**DRAFT Preliminary Review:  
Navy Groundwater Flow Model  
for the Navy Red Hill Facility**

*The Department of Health Hawaii (DOH)  
Technical subject matter experts  
Robert Whittier, Don Thomas, G.D. Beckett & Anay Shende*

*May XX, 2021*

# GW Elevation Variance – Transient Models

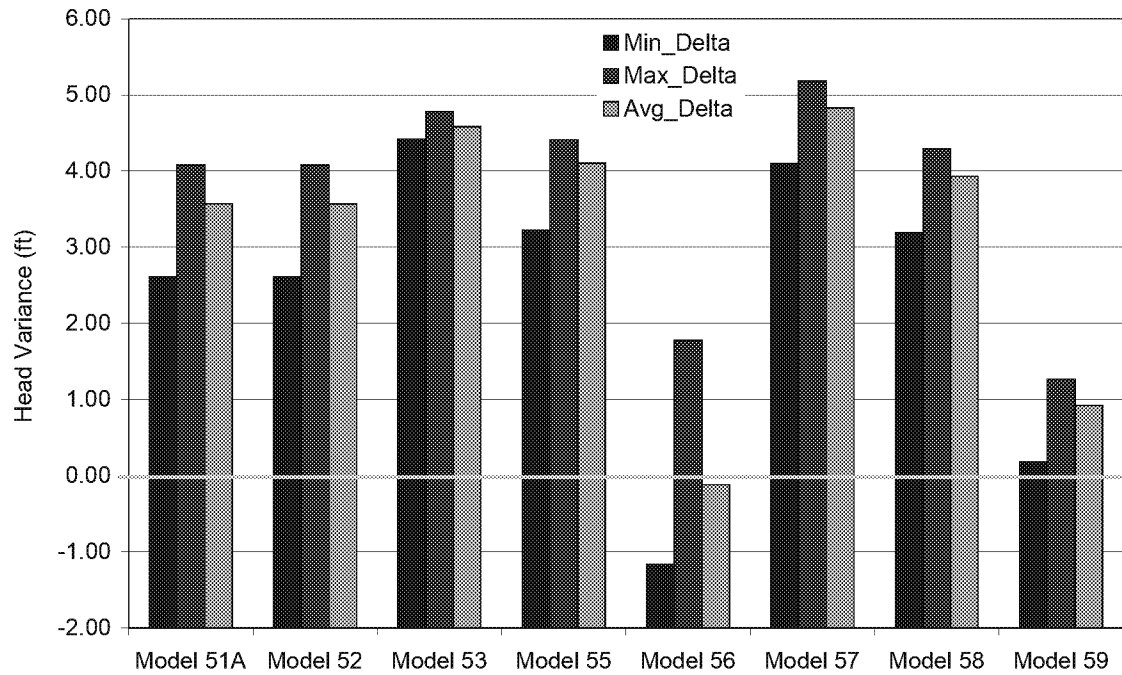
Modeled Groundwater Elevations Compared to Actual Synoptic Data  
Verification Model Variances to Measured Red Hill Area Well

## Incorporating Geochemistry w/o Doing a Transport Model

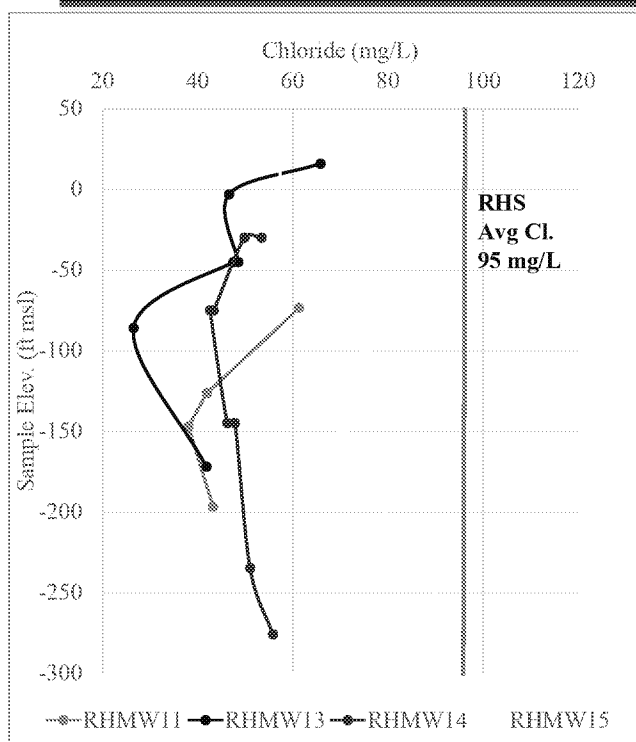
- Mixing Equation
  - $C_{\text{mix}} = (C_1 * Q_1 + C_2 * Q_2 + C_3 * Q_3) / (Q_1 + Q_2 + Q_3)$
- Modeled inflow to Red Hill Shaft
  - Deep dike water – 39%; Cl=37 mg/L
  - Moanalua Water – 59%; Cl = 82 mg/L
  - Direct Recharge – 2%; Cl = 25 mg/L
- $C_{\text{mix}}$  Calculated – 63 mg/L
- $C_{\text{mix}}$  measured - ~95 mg/L
- I believe the inflow percentages were for a RHS non-pumping condition
  - If I recall right majority of modeled inflow during pumping was deep dike water.
